Contract #: 04-0120F4Cty: SF/ALA Rte: 80 PM: 13.2/13.9File #: 69.25B**QUALITY ASSURANCE -- NON-CONFORMANCE REPORT****Location:** Changxing Island, Shanghai, P.R. China**Report No:** NCR-000769**Prime Contractor:** American Bridge/Fluor Enterprises, a JV**Date:** 19-Jun-2010**Submitting Contractor:** Zhenhua Port Machinery Company, Ltd (ZPMC), Changxing Island**NCR #:** ZPMC-0731**Type of problem:**

Reference Description: QA found some cracks in Lift 8 West by MT after ZPMC's had tested and accepted the welds

Job Name: SAS Superstructure

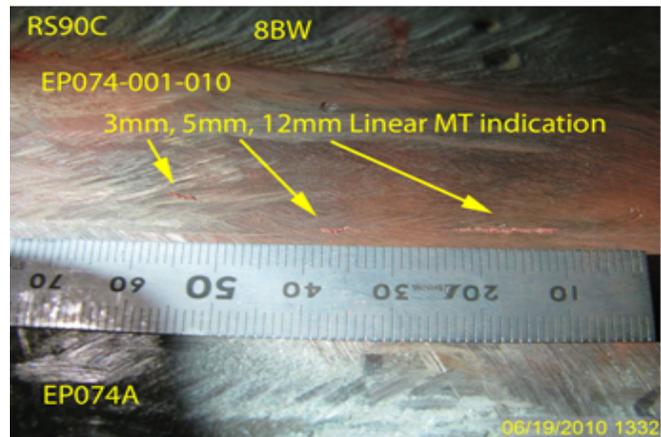
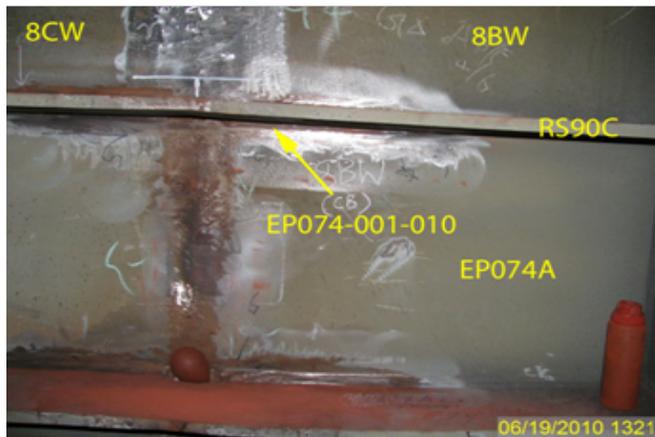
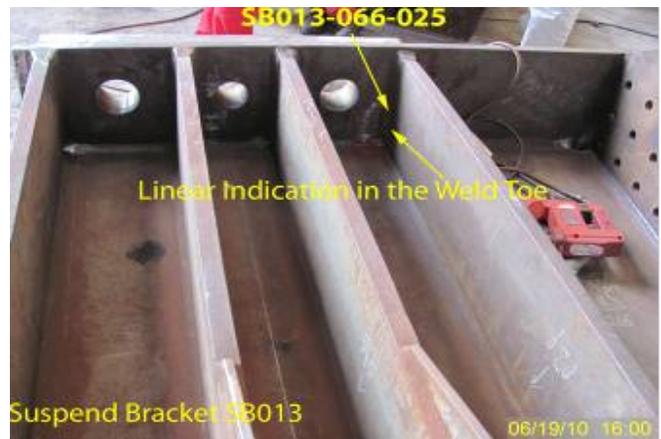
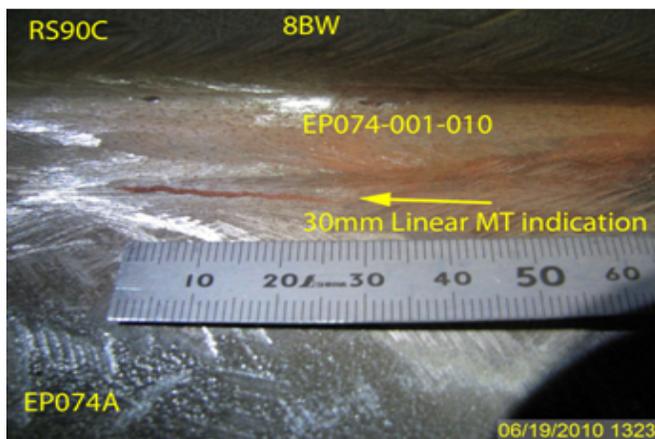
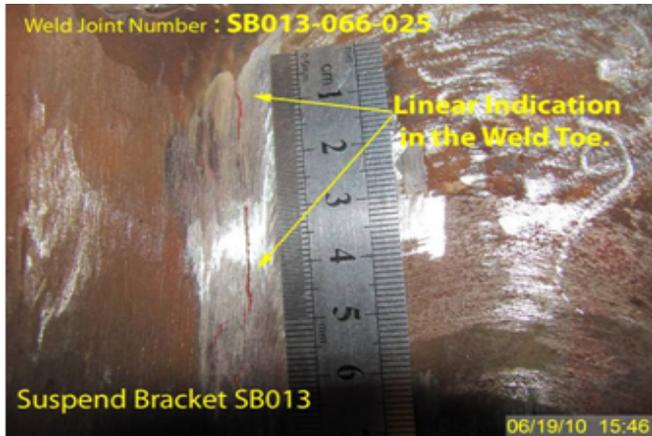
- Three (3) linear cracks measuring approximately between 9mm and 12mm in length.
- The cracks were found at temporary attachment removal areas on two side panels.
- The Side Panel on 8AW is identified as: SP434A
- The Side Panel on 8BW is identified as: SP435A
- The CJP splice weld # is designated as OBE8B-001.
- Length and Y location of the MT cracks on SP434A (8AW) are as followed: 12mm in length and 1500mm off weld joint OBW8B-002 on the counterweight side of segment.
- Length and Y location of the MT cracks on SP434A (8AW) are as followed: 10mm in length and 6000mm off weld joint OBW8B-002 on the counterweight side of segment.
- Length and Y location of the MT cracks on SP435A (8BW) are as followed: 9mm in length and 8500mm off weld joint OBW8B-002 on the counterweight side of segment.

- One (1) linear crack measuring approximately 40mm in length.
- The crack was found at a temporary attachment removal area on one side panel.
- The Side Panel on 8AW is identified as: SP445A
- The CJP splice weld # is designated as OBE8B-005.
- Length and Y location of the MT cracks on SP445A (8AW) are as followed: 40mm in length and 2890mm off edge plate on the cross beam side of segment.
- The Notice of Witness Inspection Number (NWIT) is No. 006009. The cracks are located within the area that has been previously tested and accepted by ZPMC Quality Control (QC) personnel. As per the contract documents, ZPMC's QC personnel are required to perform 100% MT inspection of temporary attachment removal sites.

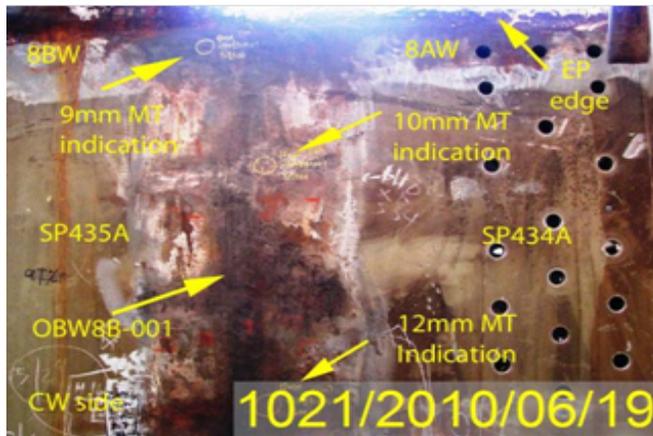
- One (1) Linear crack in the weld toe measuring approximately 45mm length.
- The weld is identified as SB013-066-025 (Lift 8BW).
- The weld is designated as Non Seismic Performance Critical Member (Non SPCM).
- The weld is located on Suspender Bracket Stiffener SB013.
- The cracks are clearly marked on the material near the weld.
- The weld is a complete joint penetration (CJP).
- The Suspender Bracket is located in Bay# 19.
- The Notice of Witness Inspection Number (NWIT) is 006012. The crack is located within area previously tested and accepted by ZPMC Quality Control (QC) personnel.

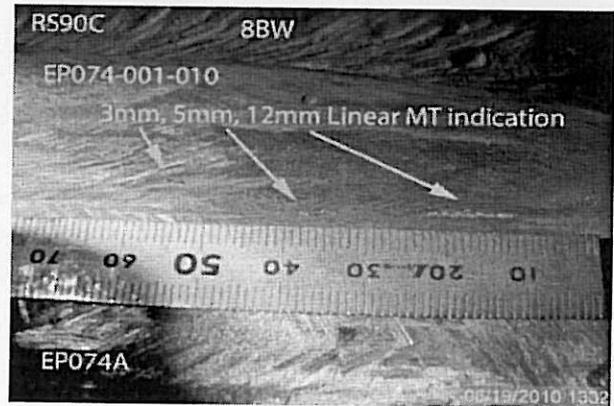
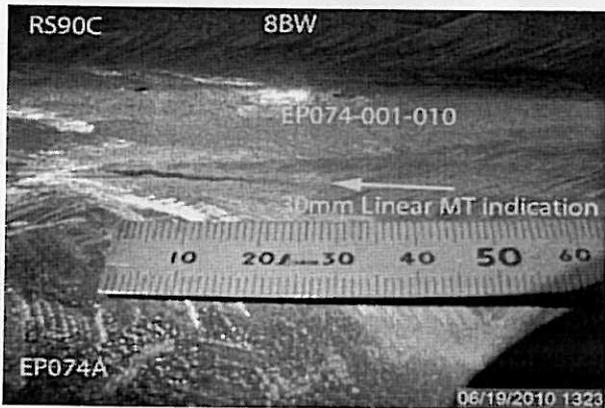
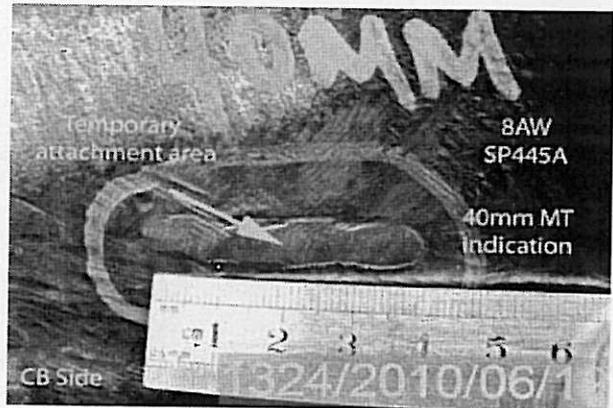
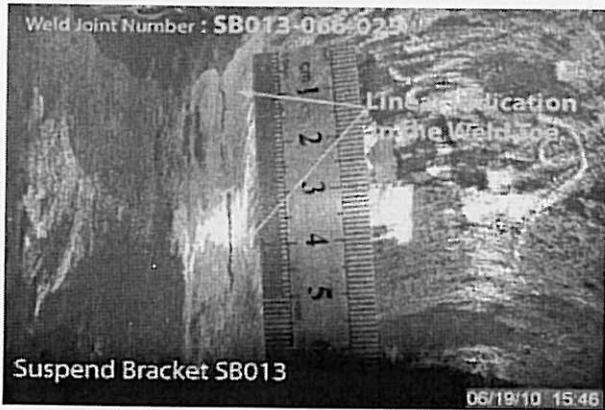
- Three (3) linear cracks measuring approximately between 9mm and 12mm in length.
- The cracks were found at temporary attachment removal areas on two side panels.
- The Side Panel on 8AW is identified as: SP434A
- The Side Panel on 8BW is identified as: SP435A
- The CJP splice weld # is designated as OBE8B-001.
- Length and Y location of the MT cracks on SP434A (8AW) are as followed: 12mm in length and 1500mm off weld joint OBW8B-002 on the counterweight side of segment.
- Length and Y location of the MT cracks on SP434A (8AW) are as followed: 10mm in length and 6000mm off weld joint OBW8B-002 on the counterweight side of segment.
- Length and Y location of the MT cracks on SP435A (8BW) are as followed: 9mm in length and 8500mm off weld joint OBW8B-002 on the counterweight side of segment.

- One (1) linear crack measuring approximately 40mm in length.
- The crack was found at a temporary attachment removal area on one side panel.
- The Side Panel on 8AW is identified as: SP445A
- The CJP splice weld # is designated as OBE8B-005.
- Length and Y location of the MT cracks on SP445A (8AW) are as followed: 40mm in length and 2890mm off edge plate on the cross beam side of segment.
- The Notice of Witness Inspection Number (NWIT) is No. 006009. The cracks are located within the area that has been previously tested and accepted by ZPMC Quality Control (QC) personnel. As per the contract documents, ZPMC's QC personnel are required to perform 100% MT inspection of temporary attachment removal sites.

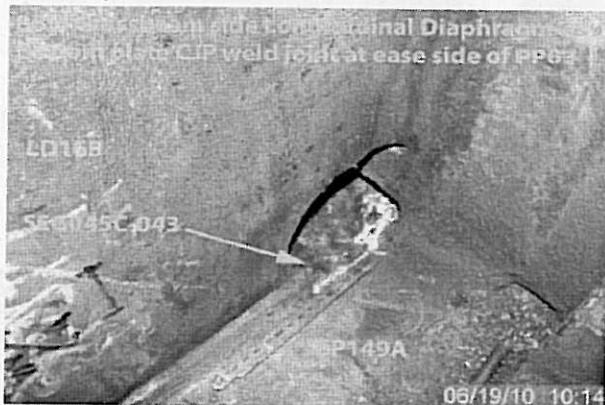
- One (1) Linear crack in the weld toe measuring approximately 45mm length.
- The weld is identified as SB013-066-025 (Lift 8BW).
- The weld is designated as Non Seismic Performance Critical Member (Non SPCM).
- The weld is located on Suspender Bracket Stiffener SB013.
- The cracks are clearly marked on the material near the weld.
- The weld is a complete joint penetration (CJP).
- The Suspender Bracket is located in Bay# 19.
- The Notice of Witness Inspection Number (NWIT) is 006012. The crack is located within area previously tested and accepted by ZPMC Quality Control (QC) personnel.
